I-5507 - Interstate 485 improvements from I-77 to US 74 (Independence Blvd)

Subject: **Request for Modification for Section 404 Regional General Permit No. 201902350 and Section 401 Water Quality Certification** for the Interstate 485 (I-485) improvements from I-77 to US 74 (Independence Boulevard), Mecklenburg County, Division 10, TIP I-5507. Debit \$570.00 from WBS 43609.3.2.

Revised July 2023
**PERMIT DRAWING
SHEET 18 OF 115**

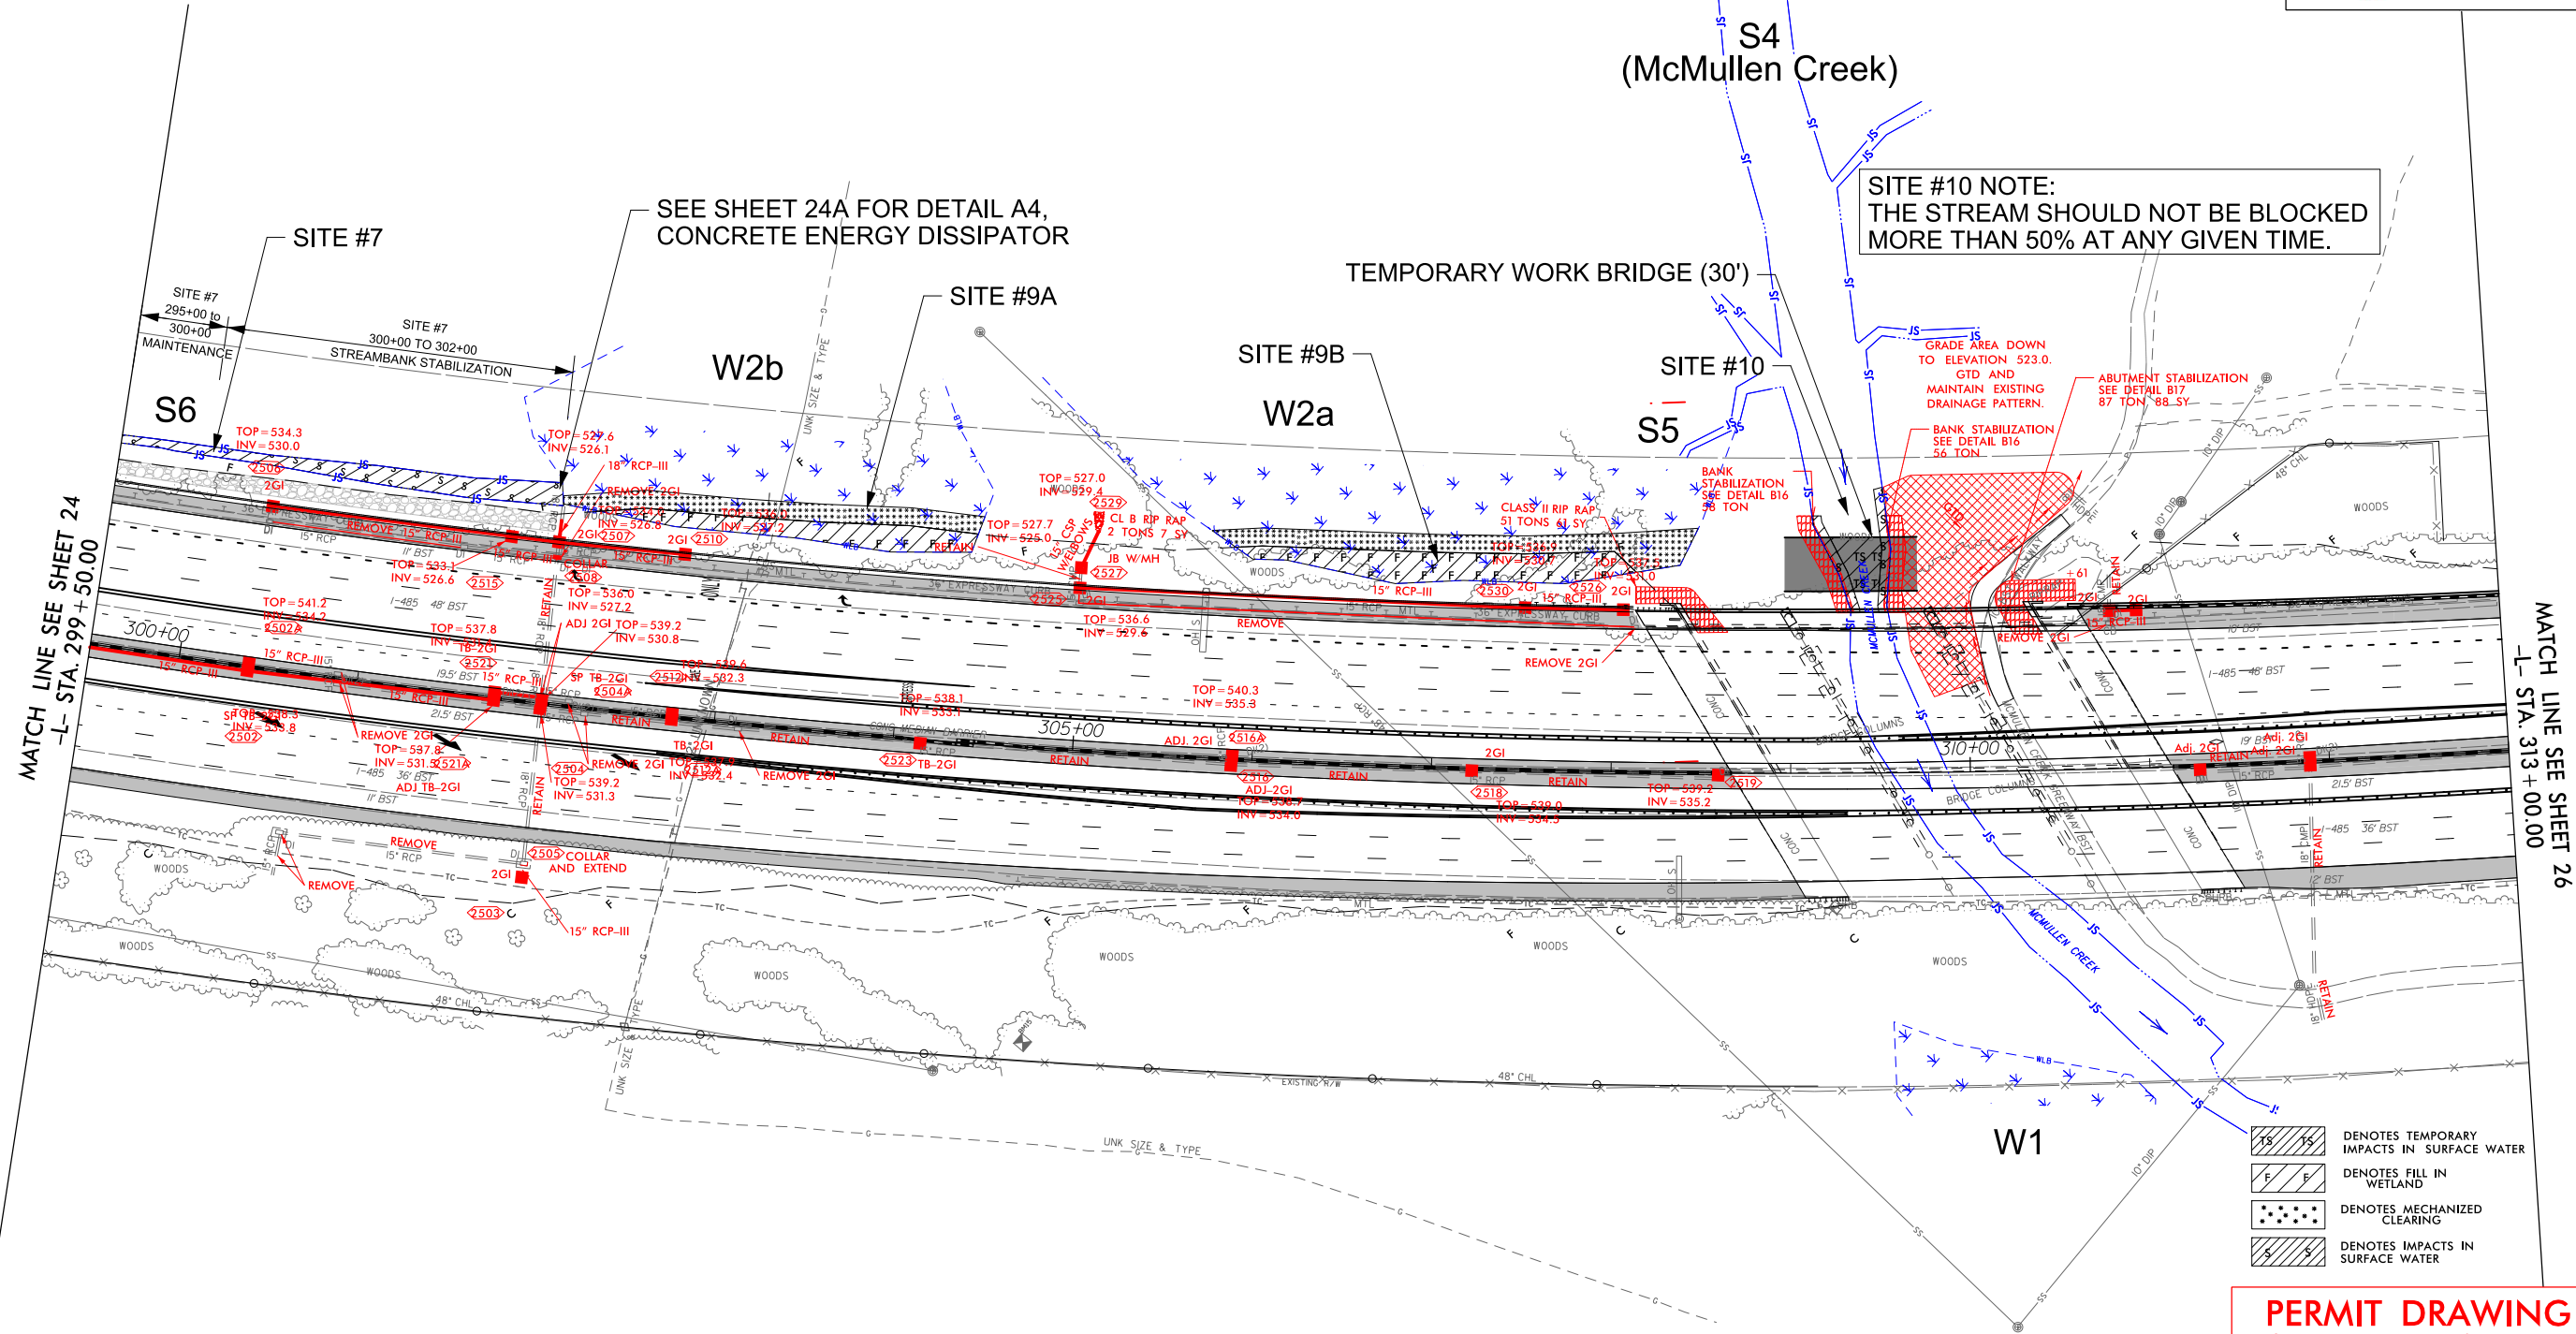
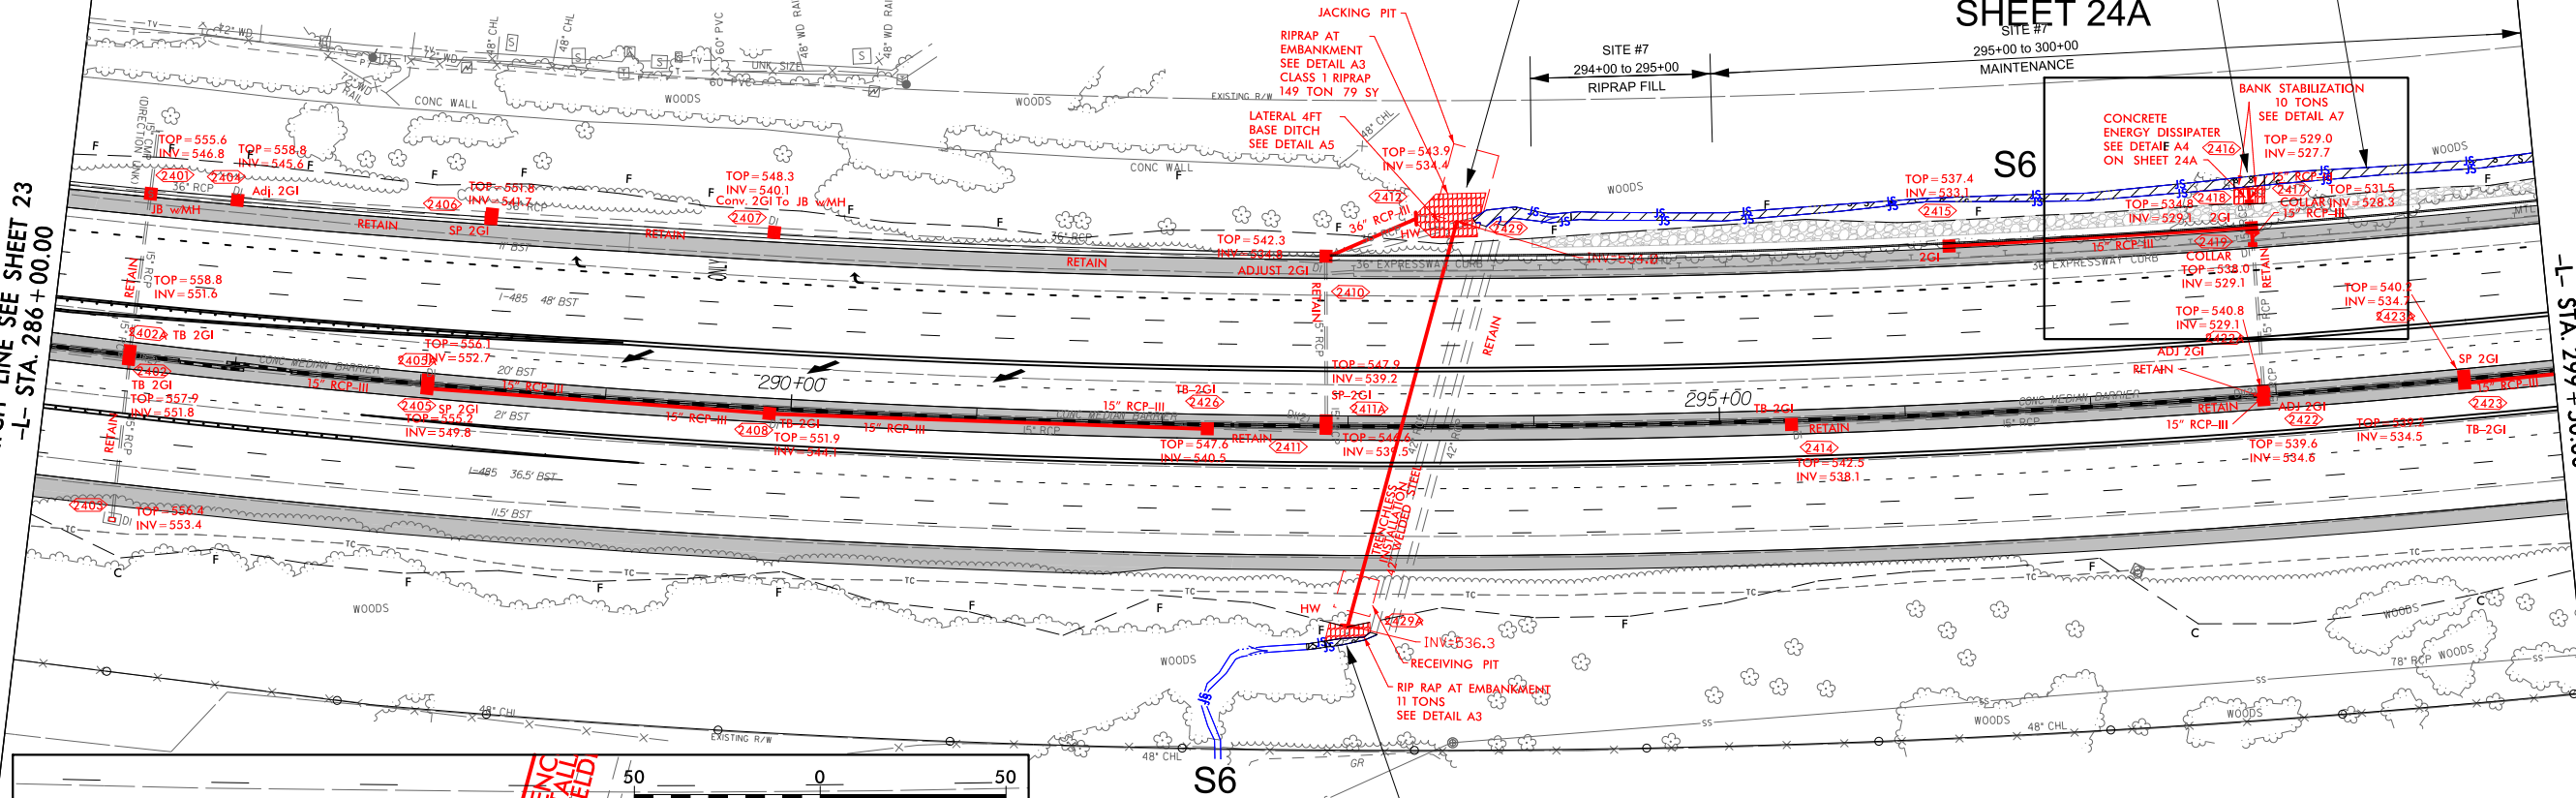
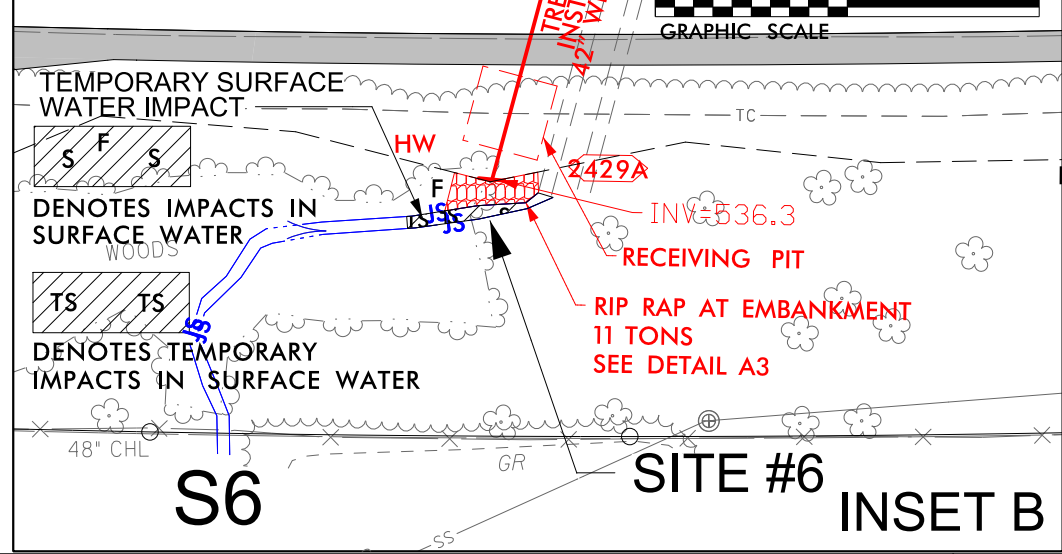
The original approved impacts at Site 7 included 680 linear feet (0.07 acre) of temporary surface water impacts in Stream S6 associated with the installation of rock plating between Stations 294+00 and 301+00. The original design did not propose extending the rock plating to below the ordinary high water mark. Through on-site coordination with and approval by Donna Hood of NCDWR during construction, permanent riprap stream bed stabilization was determined to be needed between Stations 294+00 and 295+00. In addition, through on-site coordination with NCDWR the rock plating was extended to the toe of slope between Stations 294+00 and 302+00 to prevent future scour that might jeopardize the slope and shoulder of the roadway. Following clearing of vegetation it was determined that the stream banks between Station 295+00 and Station 300+00 had been previously lined with riprap; therefore, the rock plating in these locations was determined to be a maintenance activity consisting of reconditioning the slopes. Based on these field changes, the proposed impacts at Site 7 include the following:

- Station 294+00 to Station 295+00: 100 feet of riprap fill impacts
- Station 295+00 to Station 300+00: 500 feet of stream bank maintenance
- Station 300+00 to Station 302+00: 200 feet of stream bank stabilization

The original design at Site 8, which included installation of a concrete energy dissipator at Station 298+00, has not changed. However, the stream bank stabilization identified in the prior permit approval is now accounted for in the length of stream bank maintenance for Site 7. Permanent impact for Site 8 now consists of 7 linear feet of stream bed impacts for the energy dissipator.

PERMIT DRAWING
SHEET 74 OF 115

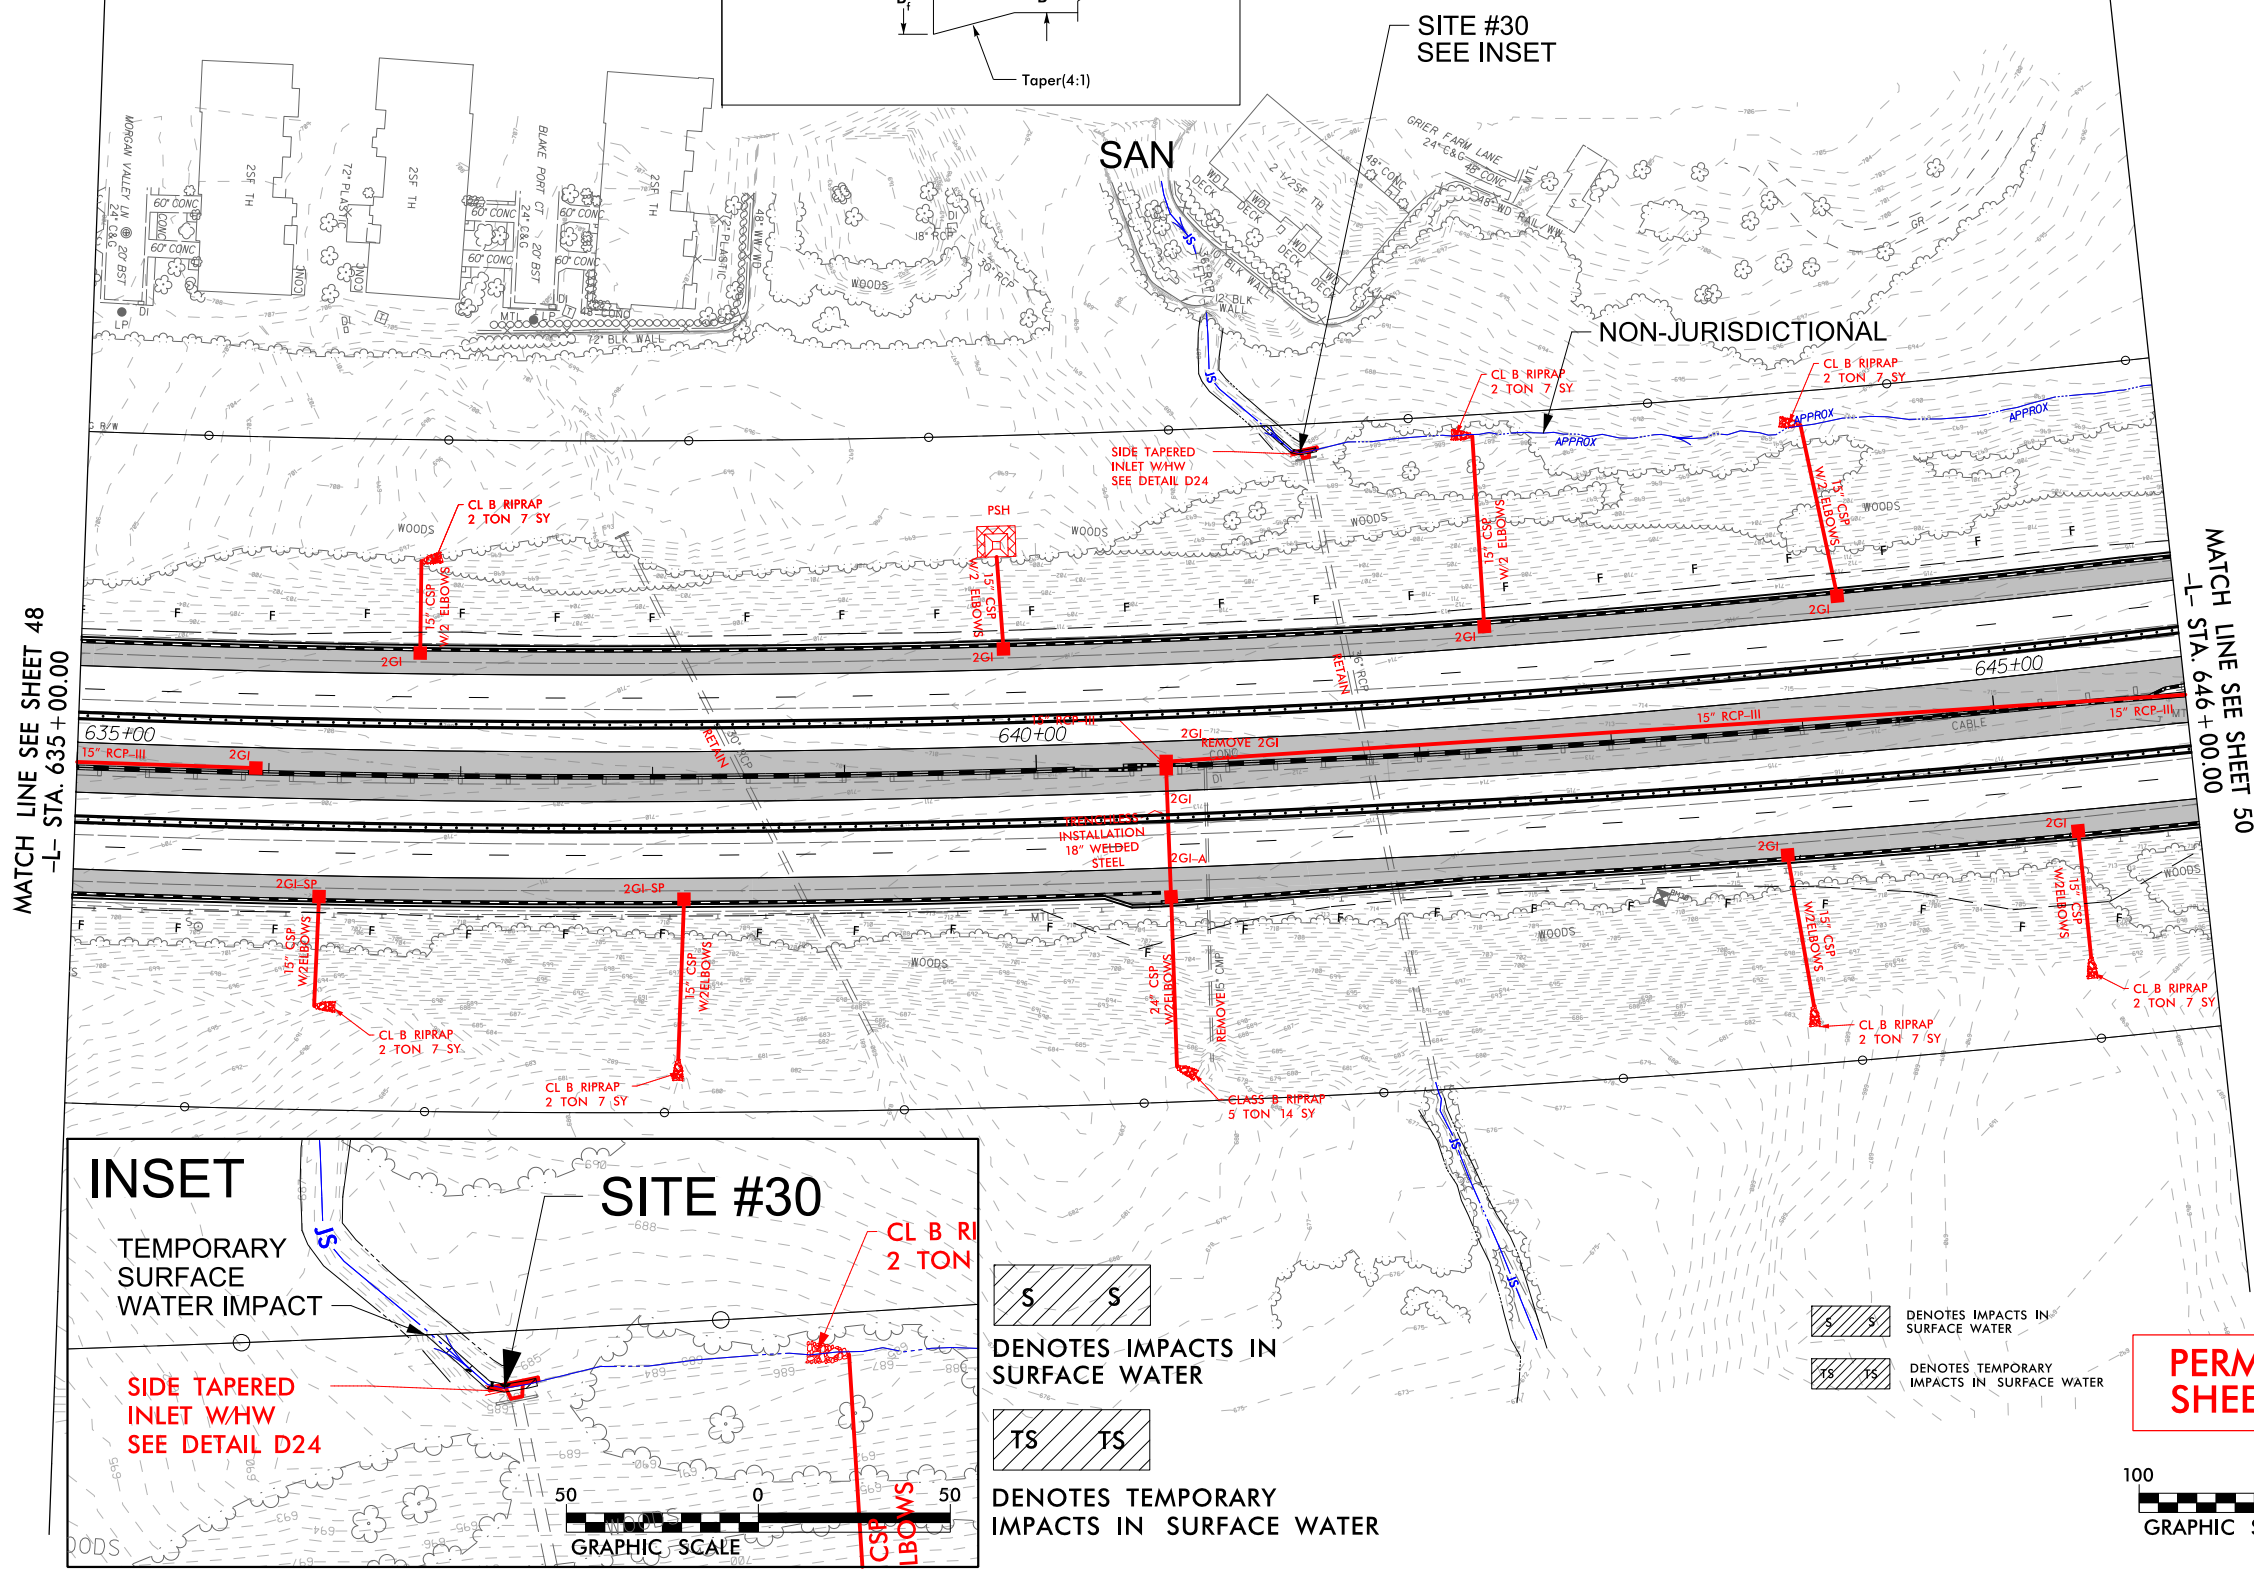
The original approved impacts at Site 30 included 33 linear feet of temporary impact to Stream SAN associated with installation of a side tapered inlet and headwall at the end of an existing 36" reinforced concrete pipe (RCP) culvert. The original design at this location included a 4-foot extension of the existing

36" RCP, which was inadvertently omitted from the permit. The revised impacts at Site 30 include 13 linear feet of permanent stream impacts resulting from the culvert extension, side tapered inlet, and headwall. Temporary impacts would be 20 linear feet.
